Re: Plan Commission Case PC 24-05

Request for an amendment to a Special Use Permit to allow the expansion of an existing school at the property commonly known as 8601 Menard Avenue in Morton Grove, Illinois (PIN 10-20-212-019-0000, 10-20-216-010-0000, 10-20-216-011-0000) with variations from Section 12-4-2:D for setback and lot coverage, all within a R-2 Single Family Residence District pursuant to Section 12-4-4:E. The applicant is a+c architects LLC on behalf of MCC Academy.

STAFF REPORT

Proposed (Left) & Existing (Right) Site Plans with "land-banked" area for potential future parking spaces (per Ord. 04-44)

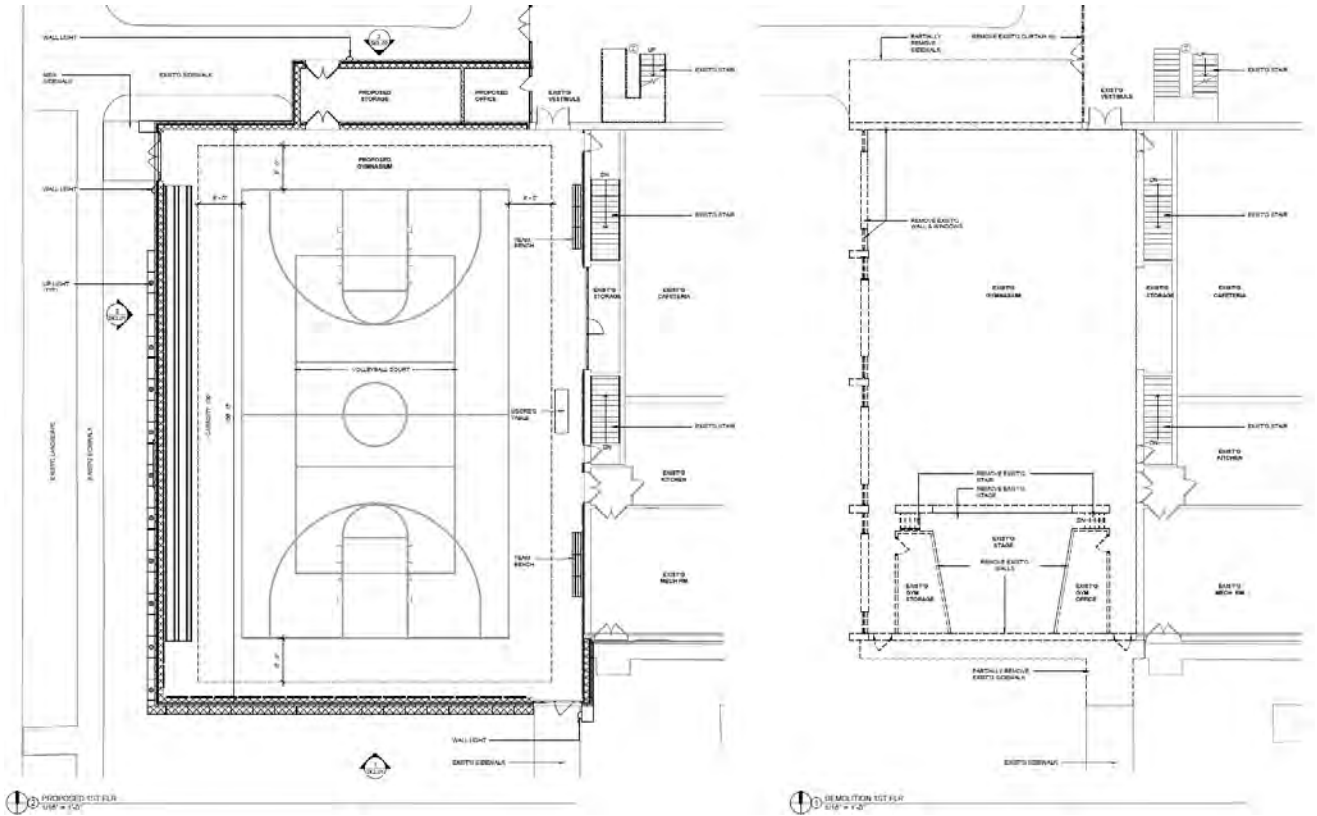
The applicant should speak to on-street parking issues and be prepared to present an alternative design of the track and field that includes additional off-street parking in the land-banked area. If the Plan Commission were to make a motion to approve the application, Staff recommends one of the following two conditions to address the MCC's current impact on on-street parking in the area and noncompliance with the mediation agreement:

- 1) *The land-banked area must be improved to provide a minimum of 23 off-street parking spaces; or*
- 2) *The proposed track design must be modified to prevent any improvement of the land-banked area to allow for future off-street parking spaces, monitoring of on-street parking must continue, and parking management measures must be implemented by the MCC in coordination with staff until the MCC becomes and remains compliant with the mediation agreement.*

9. *Prior to the issuance of a building permit, the applicant shall submit revised plans that include conversion of the land-banked area to off-street parking to include a minimum of 23 spaces and a reduced/relocated track and related lighting, subject to review and approval of the Community Development Administrator.*

Prior to the issuance of a building permit, the applicant shall submit revised plans that include a reduced/relocated track and related lighting that does not overlap with the land-banked area, subject to review and approval of the Community Development Administrator. The applicant shall also submit a letter of understanding recognizing that the Mediation Agreement (Res. 04-32) remains in place and the amended Ordinance 18-09 does not relieve the burden of monitoring on-street parking impacts related to MCC activities, nor does it mitigate the potential that the MCC shall be required to install additional off-street parking on the subject property. Parking management measures must be implemented by the MCC in coordination with staff until the MCC becomes and remains compliant with the mediation agreement.
